Your file: 71-9290, 71-9310

RE: Request for Additional Information Related to the Certificate of Compliance No. 9290
MDS Nordion's Model No. F-430 and Certificate of Compliance No. 9310, MDS
Nordion's Model F-431

ASSESSMENT OF F-430 TIE-DOWN COLLAR BOLTED CONNECTION

Figure 1: Tension on Tie-Down Collar

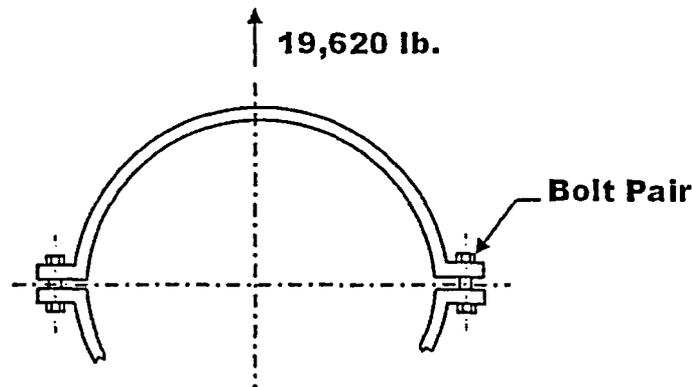
This letter is in response to the U.S. Nuclear Regulatory Commission's (NRC) Request for Additional Information (RAI) dated July 22, 2004. The additional information requested relates to the need for an analysis of the bolt stresses considering the gap in the tiedown collar joint. Please find attached a report, which analyses the bolt stresses in the tiedown collar joint.

The component of the horizontal tie-down force acting in the direction of the axis of the bolts applies tension on the bolts. As a worst-case condition, the entire horizontal tie-down force is considered to act along the axis of the bolts (see Figure 1).

$$\sigma_t = F_t/A_t = 19,620/1.725 = 11,374 \text{ psi}$$

$$SF_t = \sigma_y/\sigma_t = 80,000/11,374 = 7$$

Figure 3: Bending on Tie-Down Collar Bolts

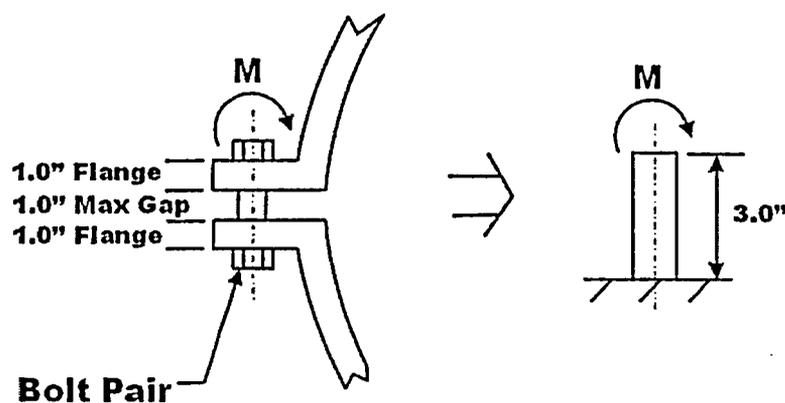
As there is a gap at the bolted connection, the shear force calculated above applies a bending moment on the bolts.

M = moment at the root of the bolts (see Figure 3)

= $F_b * (\text{maximum gap between bolts} + \text{thickness of bolt flanges})$

= $103 * (1.0 + 2.0) = 309 \text{ lb-in}$

$$\sigma_b = 309 * 0.371 / 0.03 = 3,821 \text{ psi}$$

$$SF_b = \sigma_y / \sigma_b = 80,000 / 3,821 = 21$$
